FCC APPLICATION INQUIRY RESPONSE
MIVWG9701A: INET SPIDER II MODEM
Correspondence Number: NONE
OCTOBER 8, 1998

This package was compiled to reply to inquiries made by Mr. Frank Coperich of the FCC regarding the Type Certification Application for the Inet Spider II Modem. Each Inquiry item is listed below followed by the response.

900 MHz Verification 9/16/98.MEA

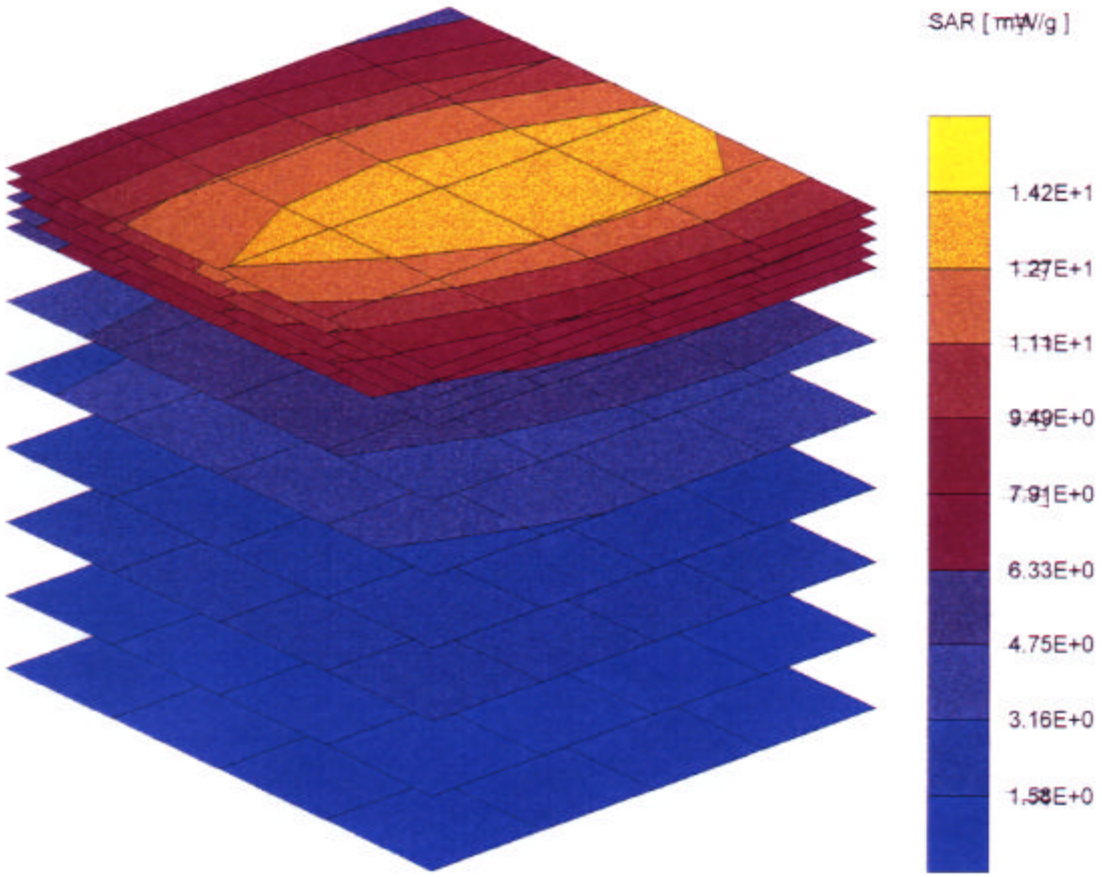
8. The SAR plots in the revised report have highest 1-g SAR as 9.47 W/kg (same as mW/g) which is much higher than the limit of 1.6 W/kg. But the test configuration photos appear to be identical to those in the previous SAR report which has very low SAR 0.0854 W/kg.

The 9.47 W/kg figure was a pre-test validation used to verify that the test setup and instrumentation is operating correctly prior to the formal test. The actual worst case SAR is significantly lower than this figure.

The following sections of this SAR data submission for the Spider II Modem are divided into the verification test and the worst case test data based on conversations with the FCC. The first portion of this appendix shows data obtained during a pre-test verification to determine that the SAR test set was operating properly. This involved insertion of a 'dummy' source into the setup and mapping the SAR emissions.
